# 5PK MICRO-V® AT BELT CHANGE ON RENAULT ENGINES

**BULLETIN:** TSB013\_AU

**PART NUMBER:**  
▪ 5PK1755

Fig. 1

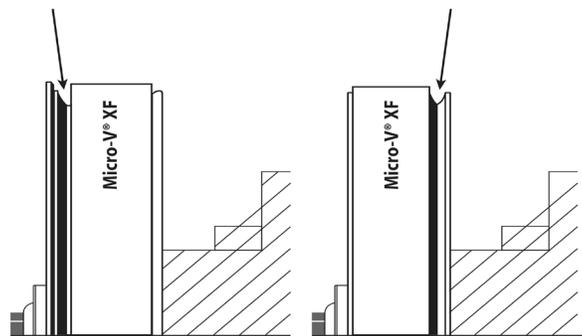
As these 5PK belts run in the initially installed 6 groove pulleys, it is important to install the belt in the correct pulley grooves. This is because there have been cases where incorrect belt placement caused the multi ribbed belt to be destroyed, resulting in parts entering into the timing belt drives and causing considerable damage to the engine.

- Without air conditioning:
  - Power steering pump is belt driven: belt has to be on the inside of the pulleys (fig. 1)
  - Power steering pump is electrically driven (not included in the belt drive): belt has to be on the outside of the pulleys (fig. 2)
- With air conditioning:
  - Belt has to be on the outside of the pulleys (fig. 2)

- Belt has to be on the outside of the pulleys (fig. 2)
